1. ALL WALL BENCHTOPS SHALL BE 30" DEEP INCLUDING BACK SPLASH (UNLESS OTHERWISE NOTED).
2. ALL ISLAND BENCHTOPS SHALL BE 60" DEEP (UNLESS OTHERWISE NOTED). RFI-52

LMC SCIENCE 313-023-T12.01-0-00.00
drawing no:
LF1-01

Los Medanos College
4CD Proj.# : L-S65-B-23-SC
Science Building

drawing title: ENLARGED PLANS FIRST FLOOR - PART "A"
building no.: LMC SCIENCE 313-023-T12.01-0-00.00
drawing no: LE1-1a
drawing of

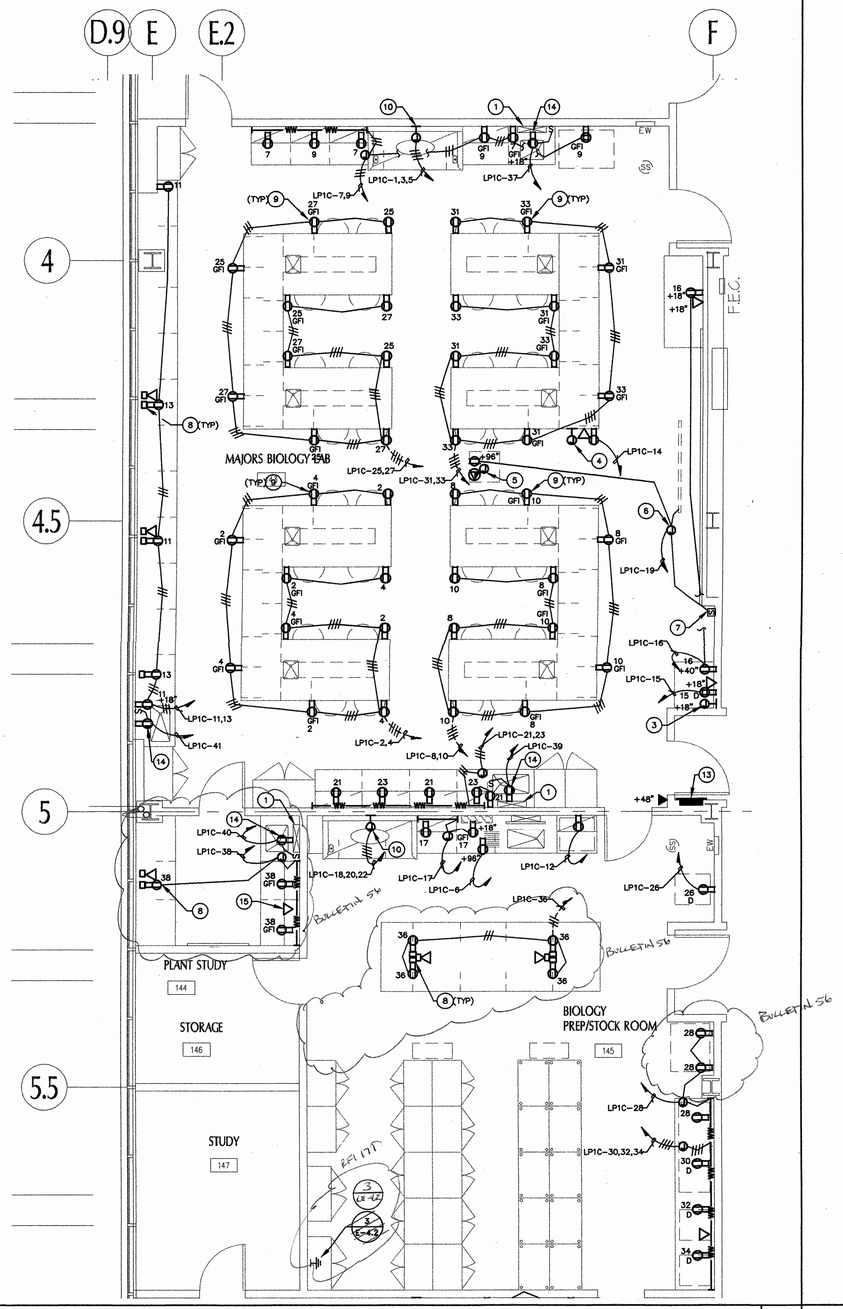
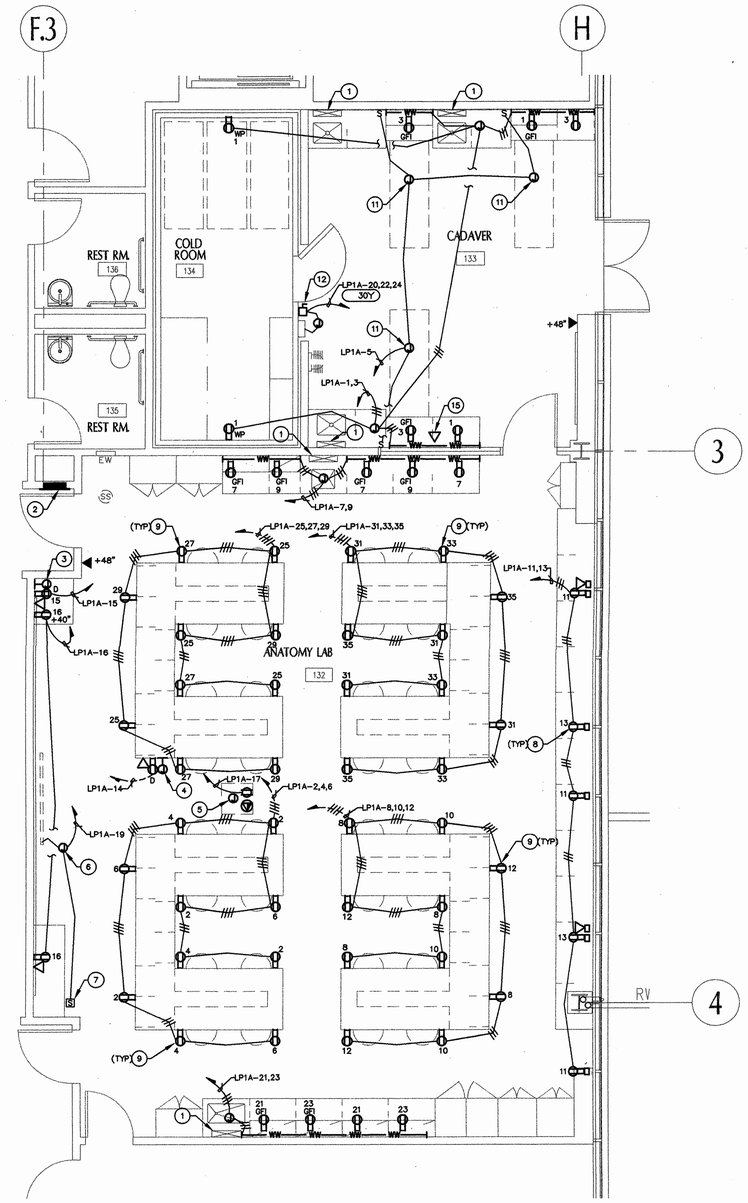
Please note the attached Edward Scott Electric RFI No. 13 regarding sheet E4.2 Detail 3 for Ground in the Biology Prep Stock Room. EWS believes that this should refer to Detail C due to the Ground being laid out under the Flammable Storage Locker. Please advise.

INFORMATION REQUESTED: PLEASE REFER TO SHEET E-4.2 DETAIL "3" FOR GRD. IN THE BIO. PREP STOCK RM. DO THEY MEAN DETAIL "C" GRD. IS LAYED OUT UNDER THE FLAMMABLE STORAGE LOCKER. IS THIS THE INTENT? IF CORRECT DOES THE GRD ORIGINATE AT GRD BAR? PLEASE CLARIFY.

1. The project drawing sheet LE1-1a Flammable Storage Locker ground detail callout should read 3/LE4-2 vice 3/E-4.
2. Detail 3 of sheet LE4-2 shows a typical ground bus installation. Typical installation of the ground bus bar would be above the grid in the accessible ceiling area, or on the wall above the locker, not under the locker. Refer to Building Electrical drawings for building ground bus system installation and connection information.
3. Coordinate connection of equipment ground with Flammable Storage Locker manufacturer.
